2019

Adelaide Hills Council

[STIRLING VILLAGE MAINSTREET DESIGN GUIDELINES CONSULTATION REPORT]

Comments on the draft Precinct Plan

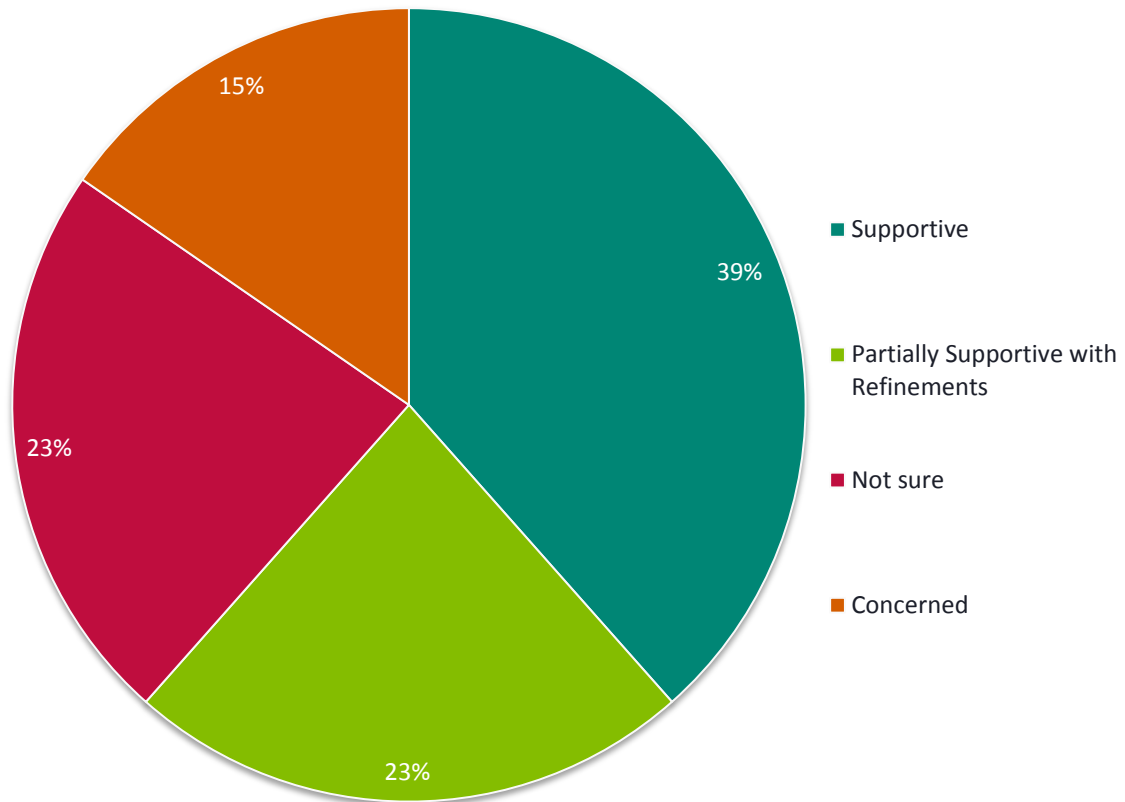
- The plan seems spot on, the Woolworths shopping centre needs updating, would love to see more car parks off the main street, and safer crossings for the hospital
- Completely misses the fact that the main street precinct extends along Druid Avenue and Johnston Street southwards. There can be improved integration between the two streets and consideration of connections to the Stirling Hospital. The precinct also extends east to Pritchard Drive and there are more opportunities to improve the streetscape and connectivity to the eastern section of the precinct, particularly for pedestrians. Would help with the sense of arrival to the precinct from the east
- There are opportunities to further consider the integration of activities, existing and proposed, along Avenue Road and Pomona Road. Consideration of the gateway into Stirling from the Freeway is needed

Comments regarding the proposed opportunity for the Corner of Mount Barker Road and Garrod Crescent:

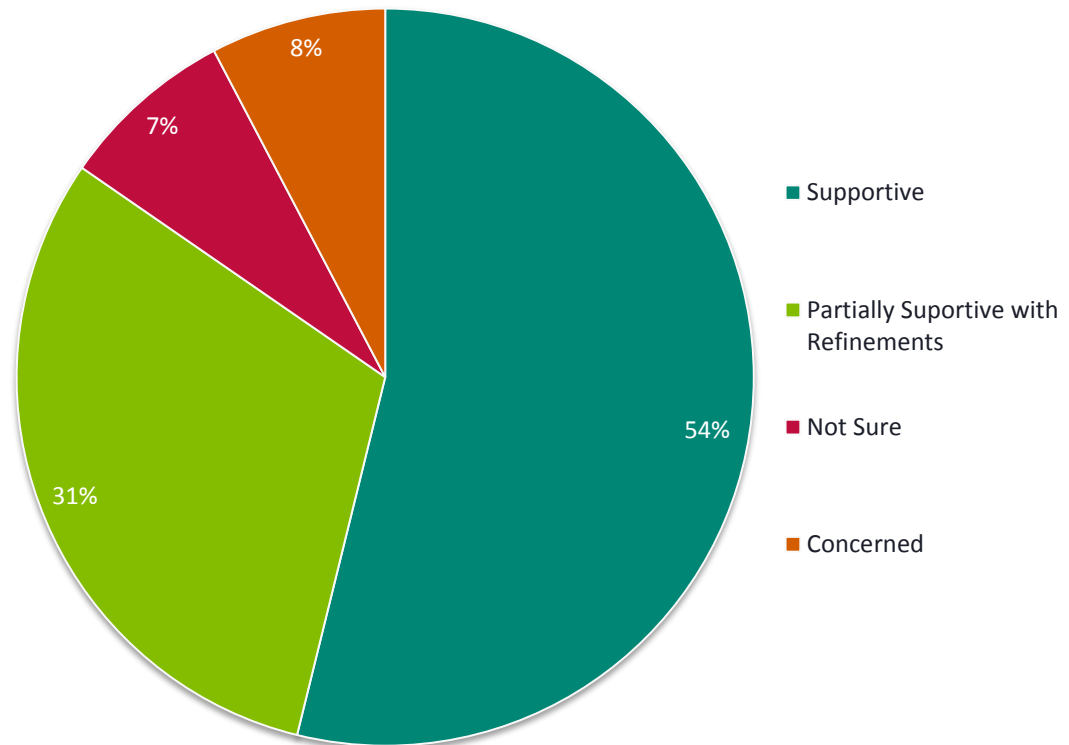
- The opportunity is an improvement on the current arrangement of buildings, car parking and poor pedestrian amenity.
- I like the concept of parking at the rear and bringing the building frontage forward....and really like the opportunity for verge landscaping.
- May work. Need more business to attract people there though. They won't walk particularly in winter.
- I don't think the narrow one way lane for cars between buildings is a good idea. Too many lane entries off the main road, complicates traffic flow in the Main Street and complicates the flow of traffic in the car park. The lane between the buildings could be for pedestrian access only. To blend with the village character the buildings should have verandah covered sidewalks. Wide sidewalks would allow for street setting.

Comments on the proposed opportunity for the Woolworths front car park:

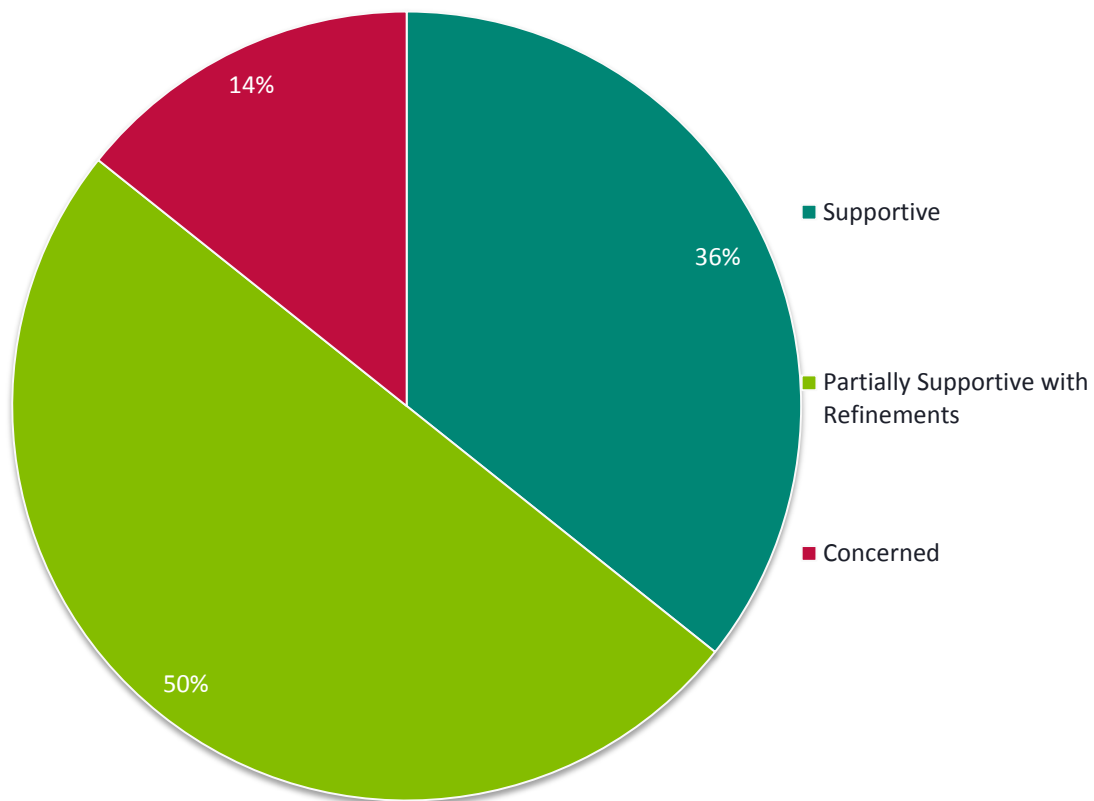
- These car parks are used by so many people all the time. Having the restricted time line means that LOCALS can use the shops with ease and speed. It is important to NOT charge people for parking in a suburban area. Many of the businesses get a boost from tourist dollars but I imagine it is the constant locals that keep them running. Removing ease and speed of parking could impede our use of these businesses.

- The car park pictured is not truly reflective of the confused car parking and traffic circulation present in the area fronting Woolworths. There are multiple entry points, different car parking areas and multiple conflict points with pedestrians. Improving these is a priority.

- Good plan. The car park in front of Woolworths is so bad it should be removed and the space developed ASAP. People (with children) walk through the car park behind reversing cars. The only problem is there will be no close parking or loading zones. I think there should be a few loading zones
